Caroline Skuncik, Executive Director
I-195 Redevelopment District
225 Dyer Street, Fourth Floor,
Providence, RI 02903

RE: Parcels 14 & 15, Final Plan Approval Recommendation

Utile and the I-195 Redevelopment District reviewed the Final Plan Application materials provided by CV Properties for the Dyer Wharf development on Parcels 14 & 15 after they were submitted on December 22, 2025 and revised on January 27th and 29th to include supplemental information requested. Preceding this, the District and Utile provided informal feedback to the development team during several prior meetings.

Exhibit 1: Allowed Long-Term Bike Parking Design

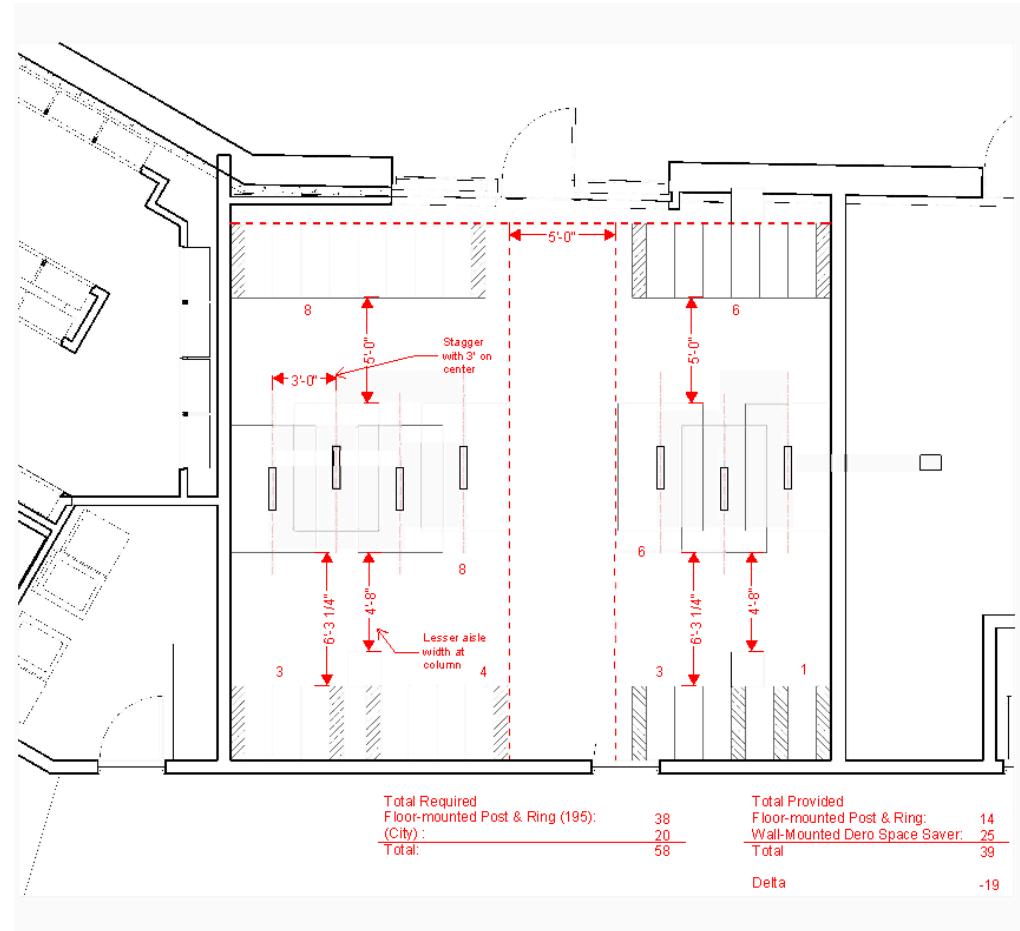
1. Long-Term Bicycle Parking:

2.4 Parking & Loading, Section 2.4.D Bicycle Parking Design Standards, Table 2.4-1 Minimum Bicycle Parking Requirements & Dimensional Standards 2.4.D.1.a and 2.4.D.2.c.

A reduction in the minimum number and an allowance for altered design for a limited number of the required Long-Term Bicycle Parking Spaces. Specifically, allowing the design of the bike room attached to this memo as **Exhibit 1**, which uses a mix of floor-mounted post and ring racks and wall-mounted racks, for a total of 39 spaces. Because this is the first and most dimensionally constrained phase of a multi-phase development, we recommend that the deficit of 19 Long-Term Bicycle Parking Spaces associated with this development be provided as part of the later phases of the development and made available to residents of this building.

Exhibit 2: Allowed Short-Term Bike Parking Location(s)

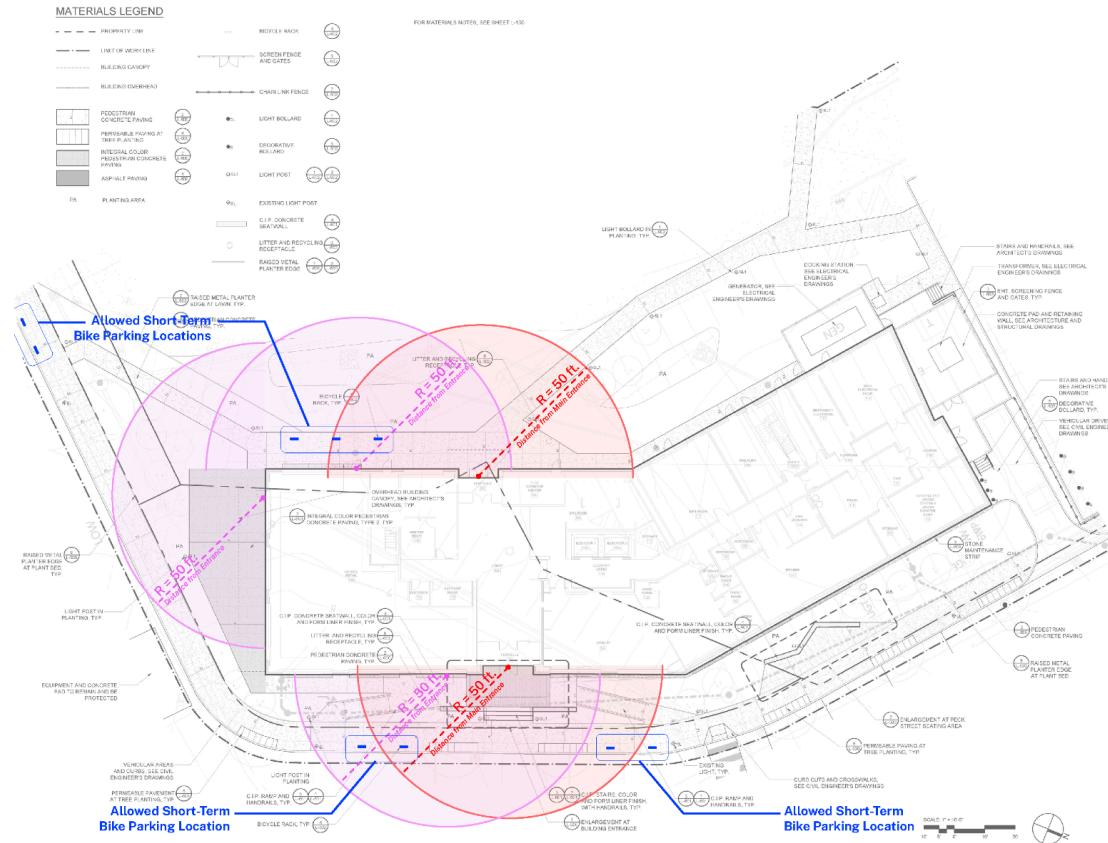
2. Short-Term Bicycle Parking:

2.4 Parking & Loading, Section 2.4.D.1.b Bicycle Parking Design Standards
An allowance for the required Short-Term Bicycle Parking Spaces to be located more than 50ft from the primary entryways to the residential units and ground floor retail space, provided the spaces are located on the closest available level sidewalk or plaza space that avoids conflicts with crosswalks and accessibility features, street trees, above-ground utility features, and walkways from sidewalk grade to DFE-1. Specifically, allowing Short-Term Bike Parking spaces to be located in the places indicated by the diagram attached to this memo as **Exhibit 2**.

Exhibit 3: Allowed Exterior Loading Dock Design

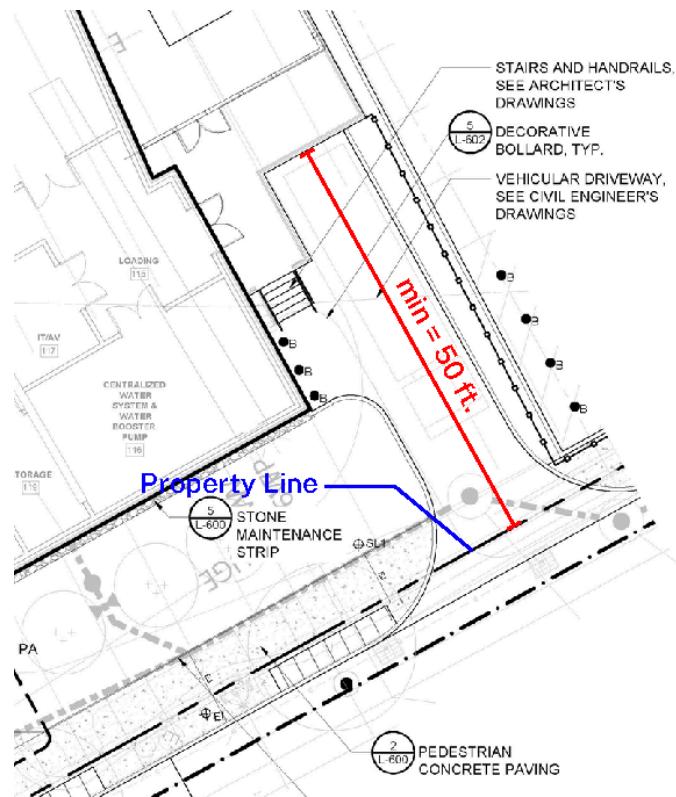
3. Exterior Loading Docks:

2.4 Parking & Loading, Section 2.4.E.3

Allow an exterior loading dock along Peck St where there will be the least impact on public realm experience, provided they are set back from the property line by at least 50 feet as indicated in the attached **Exhibit 3** and all loading support spaces, including trash, are located on the interior of the building. Stairways and pedestrian access to the loading dock and associated interior spaces are permitted be closer to the property line.
